L. William Pearce
Site Vice President724-682-5234
Fax: 724-643-8069July 24, 2003
L-03-113U. S. Nuclear Regulatory Commission
Attention: Document Control Desk
Washington, DC 20555-0001**Subject: Beaver Valley Power Station, Unit No. 1 and No. 2
BV-1 Docket No. 50-334, License No. DPR-66
Cycle 16 Steam Generator Tube Inspection 90 Day Report****Reference 1: NRC Generic Letter 95-05, "Voltage-Based Repair Criteria for the Repair
of Westinghouse Steam Generator Tubes Affected by Outside Diameter
Stress Corrosion Cracking," August 3, 1995.**

BEAVER VALLEY UNIT - 1
CYCLE 16 VOLTAGE-BASED REPAIR CRITERIA
90-DAY REPORT

Response to the NRC's Request for Additional Information (RAI) As Requested in the NRC Letter (Colburn to Pearce) Enclosure 3 Dated June 4, 2003

Figure A-1

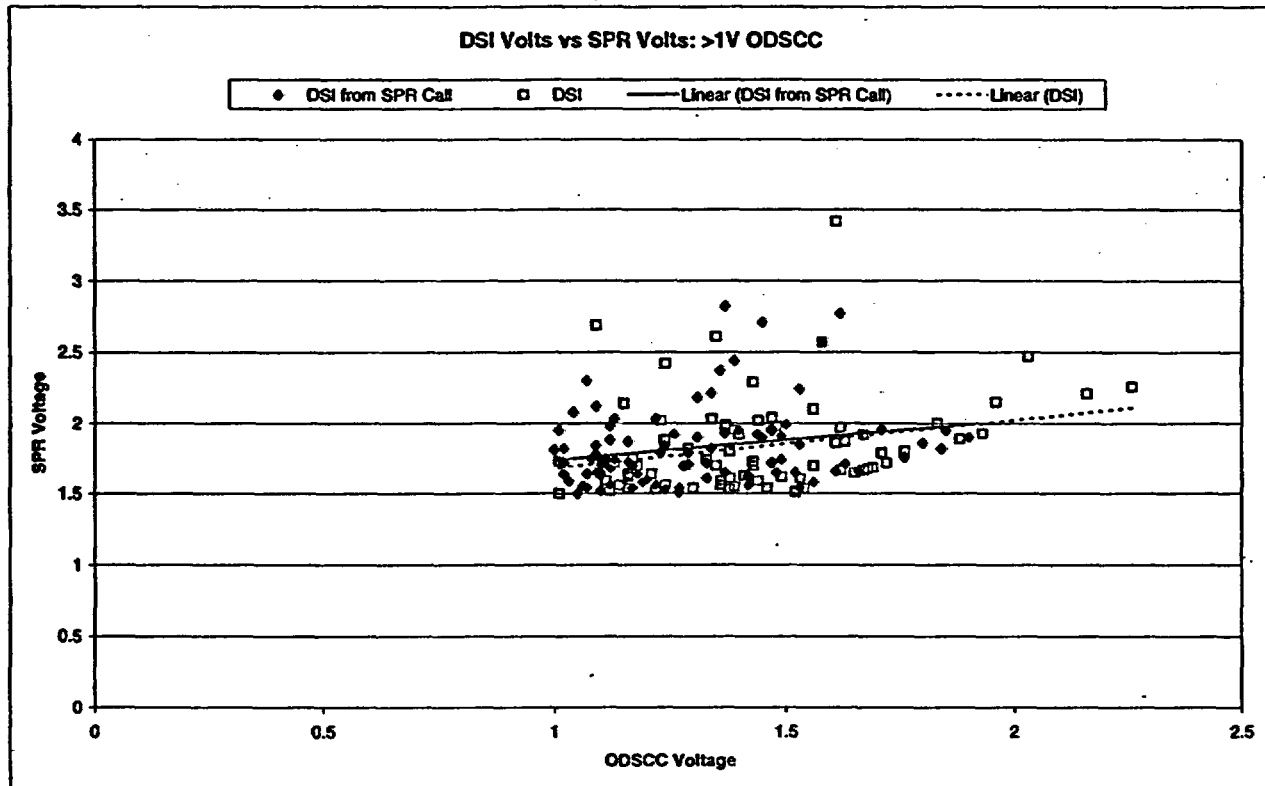
2. *Please summarize the total number of SPRs identified, the number that were inspected with the +Point probe, and the number of flaws identified at these locations during the +Point probe examination. For those indications where a flaw was identified during the +Point probe examination, indicate whether the flaw was identifiable in the 200 kHz bobbin coil data and the resultant voltage from the mix channel. For all flaws identified with a +Point probe at SPRs, provide the voltage of these flaws using the +Point amplitude to bobbin voltage correlation.*

Provide a plot of the "resultant" bobbin probe flaw voltage as a function of SPR voltage. Discuss any trends. Plots of the "resultant" bobbin probe voltage should be from both the 200 kHz sizing method and the +Point correlation sizing method.

Figure A-1 presents the ODSCC measurement from SPR calls made by CDS and ODSCC measurement of those signals called DSI by manual analysis against the total residual measurement for these intersections. These data show that for the magnitude of the SPR signals at BVPS Unit 1, that this magnitude is not affecting the ODSCC measurement compared to those signals initially called DSI, and the magnitude of ODSCC in those signals called SPR by CDS is not greater than the ODSCC measurement in those signals called DSI compared to the total residual measurement. Linear regressions are provided for each of these 2 datasets. The regressions are essentially equal for both datasets. To provide for a consistent comparison, the DSI dataset includes only those signals with total residual measurements ≥ 1.5 volts.

In general, the ODSCC measurement using 200 kHz bobbin resulted in larger ODSCC amplitudes compared to the +Pt correlation. As such, the +Pt correlation was not used.

Figure A-2

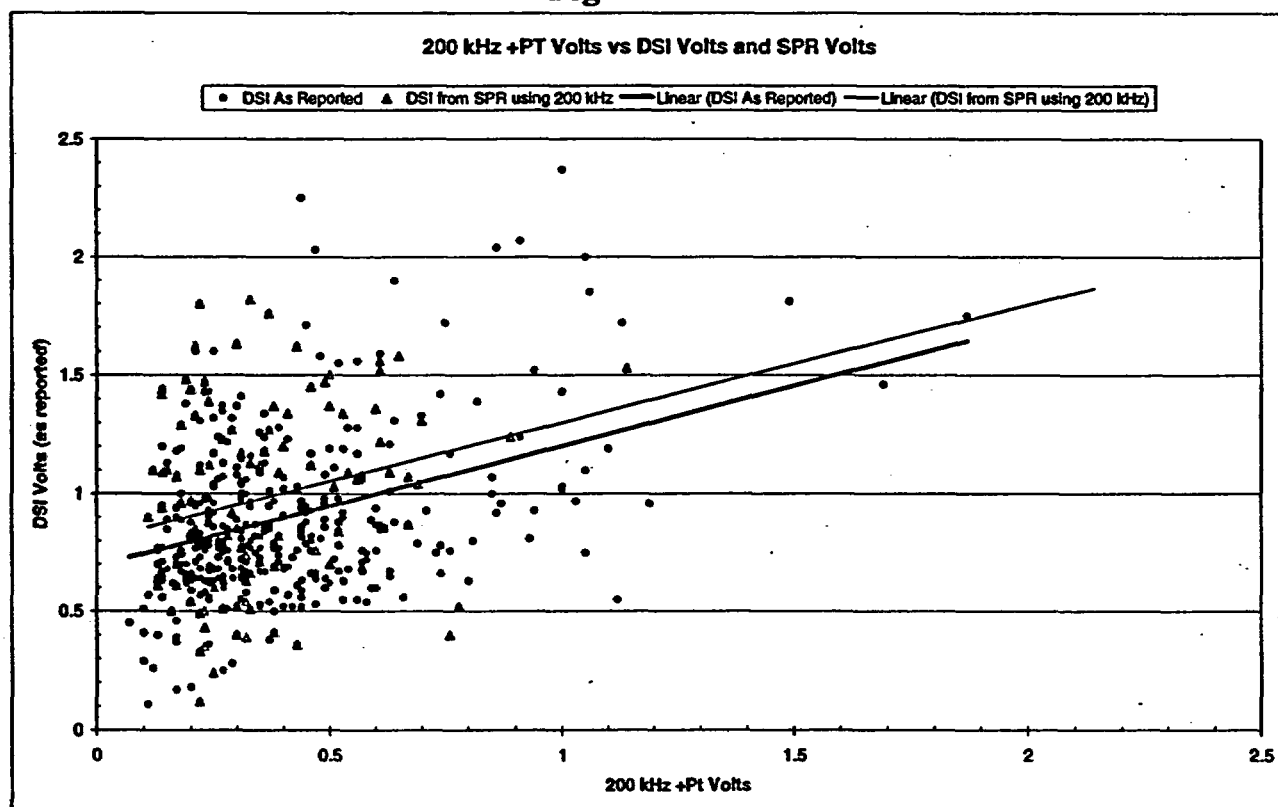
Provide a plot of the 200 kHz sizing method flaw voltage as a function of the +Point correlation sizing method flaw voltage. Discuss any trends.

In telephone conferences between FENOC and NRC during the 1R15 outage, the issue of the scatter in the data was brought up by the NRC. The scatter in the below data is entirely typical of DSI signals contained within the GL 95-05 database. The bobbin coil integrates the total signal response at a particular elevation. As the ODSCC morphology can contain multiple initiation sites at a particular elevation, the bobbin coil amplitude can be increased from one intersection to the next merely due to the number of initiation sites. Thus, a fair amount of scatter can be expected in the bobbin amplitude measurement. Figure A-2 clearly shows that for the BVPS Unit 1 population of DSIs and SPRs determined to contain ODSCC that the +Pt coil amplitude response is consistent, regardless of the bobbin indication call.

Figure A-3

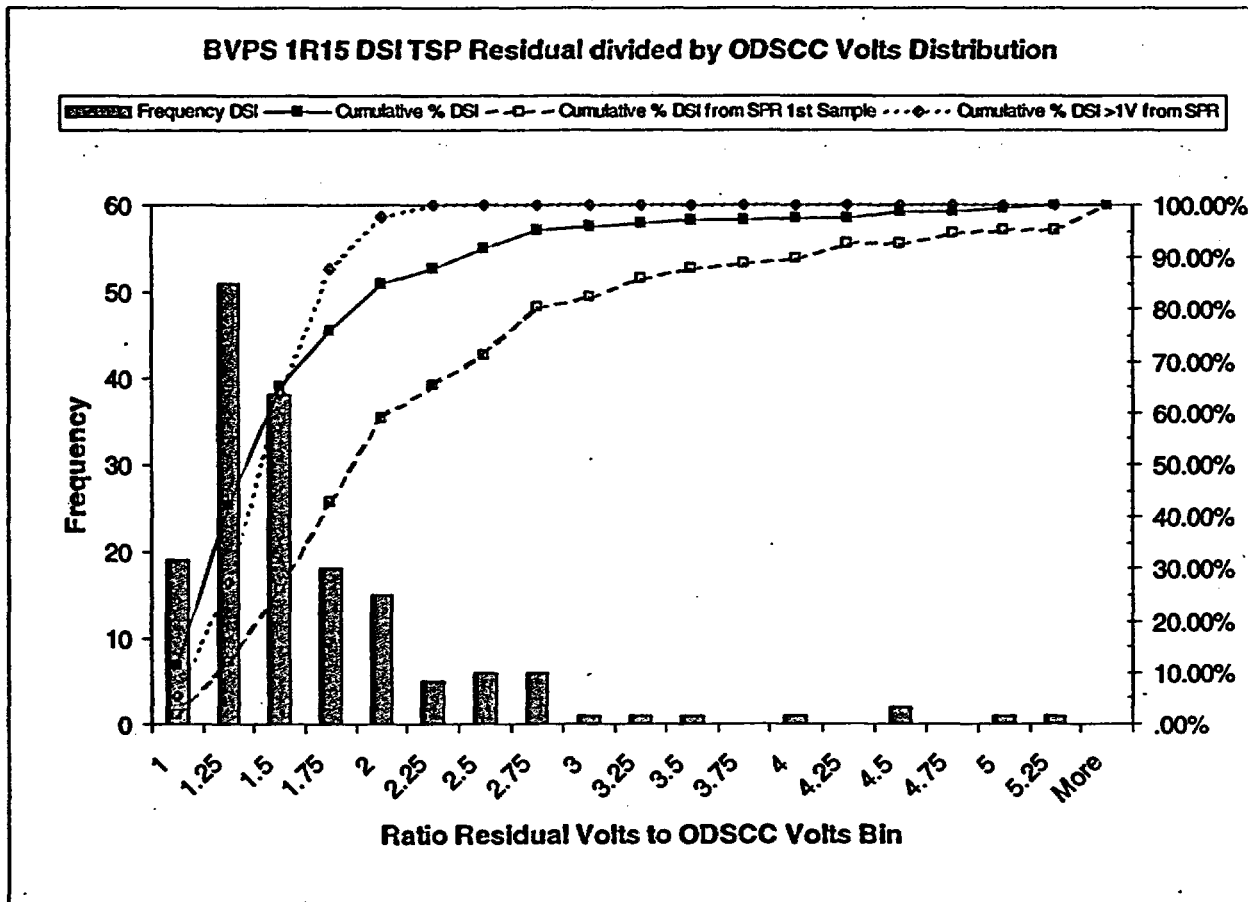
4. *Plot the relationship between the 200 kHz bobbin amplitude and the 400 / 100 kHz mix amplitude for: (1) DSIs with no or negligible SPR signals (and no or negligible dent signals), and (2) DSIs associated with an SPR (or dent) signals. Compare the two graphs and discuss any trends.*

FENOC Response: It must be noted that signals initially called DSI contain a total residual signal that is larger than the DSI ODSCC voltage measurement. The magnitude of this residual can be several times larger than the ODSCC measured within the intersection. As the largest SPR confirmed to contain ODSCC was 2.82 volts, the ratio of residual to ODSCC measurements for DSIs is similar to that for SPR determined to contain ODSCC. A random sample of 166 DSI signals was investigated to determine the distribution of residual and ODSCC measurements. Figure A-3 presents a cumulative distribution plot of the ratio of the residual to ODSCC measurement for indications initially reported as DSI. To compare DSIs with no or negligible SPR signal would result in an indirect comparison of the two datasets.

As seen from Figure A-3, DSI signals were found to contain residual components as large as 5.25 times the ODSCC component. For the initial SPR sampling program, 95% of the intersections had a SPR divided by DSI ratio within this range, whereas for all intersections initially called SPR and subsequently changed to DSI, 91% of the indications were bounded by a ratio of 5.25. For those SPR intersections determined to contain an ODSCC component >1V, the ratio of SPR to DSI amplitude was entirely bounded by the range of ratios for the 166 DSI sample. Thus, for the SPRs signals determined to contain ODSCC >1V, the total residual was less than the total residual for indications initially called DSI.

Figure A-3 shows that for the initial SPR sample, which included all SPRs >2V as well as 100 SPRs per SG that could mask or cause a 1.0 volt ODSCC signal to be masked or misread, the ODSCC component was generally closer to the SPR amplitude than for the remainder of the SPR data set. The majority of the indications repaired by plugging at 1V ODSCC component came from the first SPR sample.
